Application Ref: **2005/3407/P**  
 Please ask for: **Hugh Miller**  
 Telephone: 020 7974 **2624**

#### Full Planning Permission Refused

Address:  
**15G Gloucester Avenue**  
**London**  
**NW1 7AU**

Removal of 2nd floor patio window and 3rd floor window and replacement with double glazed timber windows at rear of flats (Class C3).

2nd floor rear patio doors : Existing Glazing

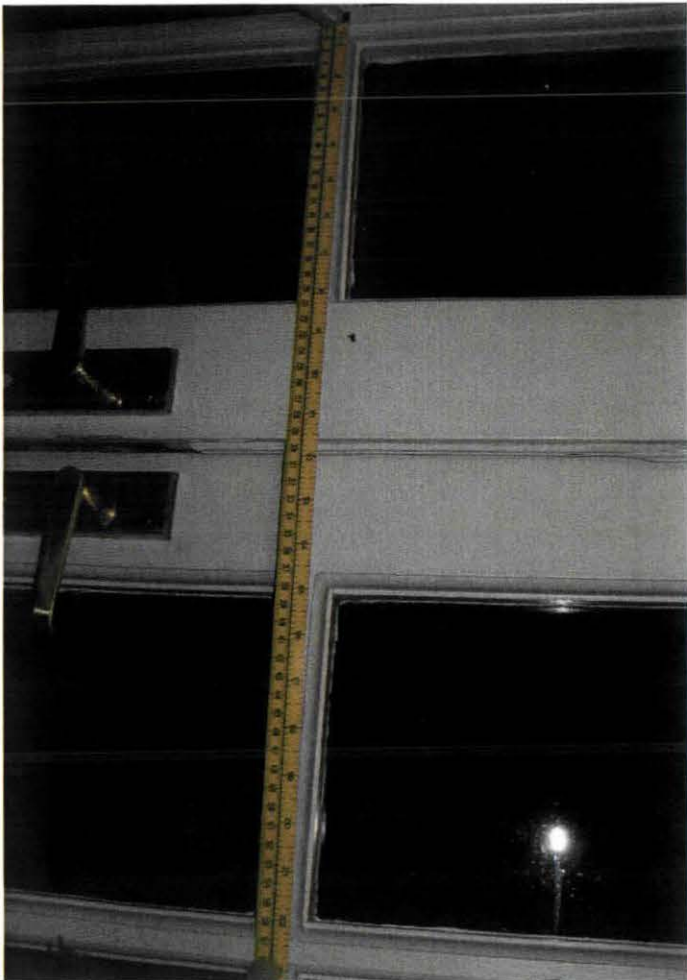
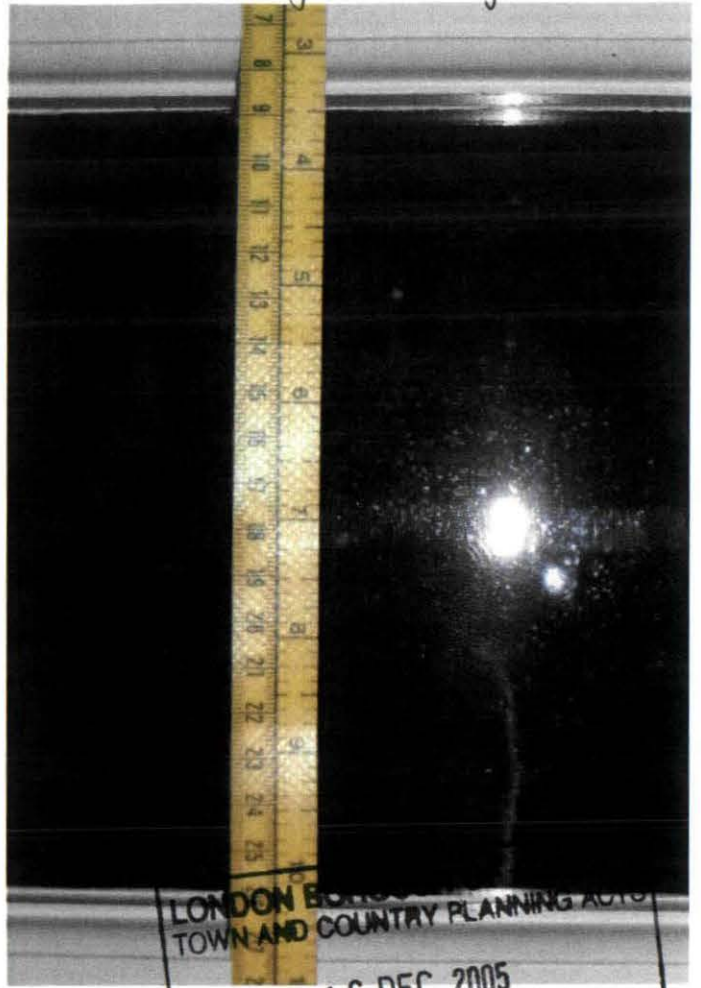
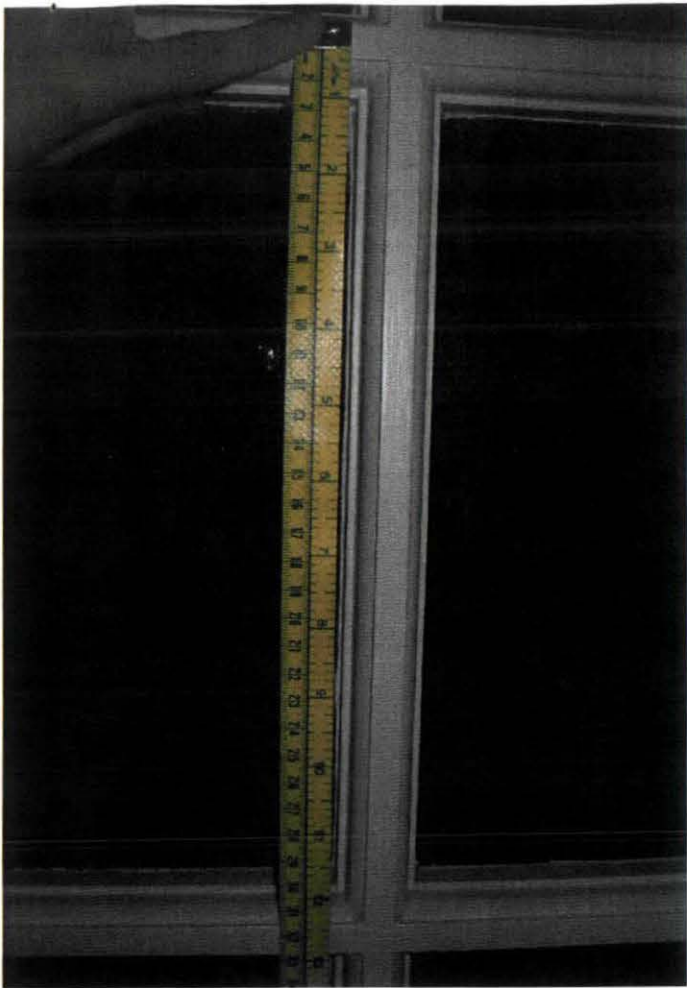
The proposed patio door utilises stuck on glazing bars. This is an inappropriate method of application of the glazing bars for the replacement double doors and window. The proposal is unacceptable and an inappropriate design solution for the listed building, and is therefore considered contrary to EN38.

The drawings are not titled existing and proposed. It is assumed the CAD drawings are the existing and the hand drawn drawings the existing, but this should be confirmed.

The proposed patio door utilises stuck on glazing bars. This is unacceptable as it is an inappropriate method and false design solution in a listed building, and is therefore considered contrary to EN28.

The proposed glazing bars should have a profile to match the existing glazing bars, which should form an integral part of the proposed patio door.

Any revised proposal should either recreate the same pattern of 24 panes of glass arranged in 4 columns of 6 or an alternative multi-pane design of fewer panes. As the door is not original fabric, or considered of special historic interest, this would be considered an acceptable design solution.

The proposal should be revised so as the glazing bars are an integral part of the proposed patio door. These glazing bars should have a profile no larger than the existing glazing bars.

Any revised proposal should either: recreate the same pattern of 24 panes of glass arranged in 4 columns of 6; or an alternative multi-pane design of fewer panes. As the door is not original fabric, or considered of special historic interest, this is considered an acceptable design solution.
